Re: GVRE Filing 15 (#1571504)/Pre-Application Meeting held September 02, 2021

On behalf of Oakwood Homes and Terracina Design, we have reviewed the comments dated September 15, 2021. The following is a response to comments.

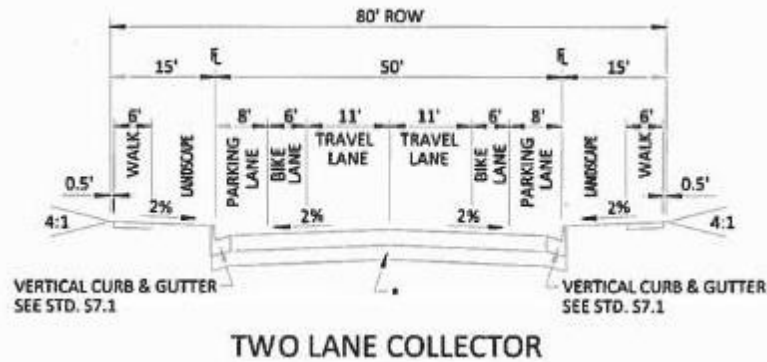
Double frontage lots shall not be permitted adjacent to local or collector streets and shall be avoided to the maximum extent practicable along arterial streets (Section 146-4.3.10.C). Where double frontage lots along arterial streets cannot be avoided, buffering of back yards from those streets shall include a landscaped buffer at least 20 feet in width between the rear lot line of any residential lot and the closest edge of the curbside landscaping area adjacent to the street, per Section 146-4.7.3.

The proposed plan includes lots that back to Tibet Road, which is classified as a collector. You are encouraged to re-work the plan to minimize the number of double fronted lots. **RESPONSE: Plan has been reworked as much as possible to minimize double frontage. 6 lots or 4% of lots will be double frontage.**
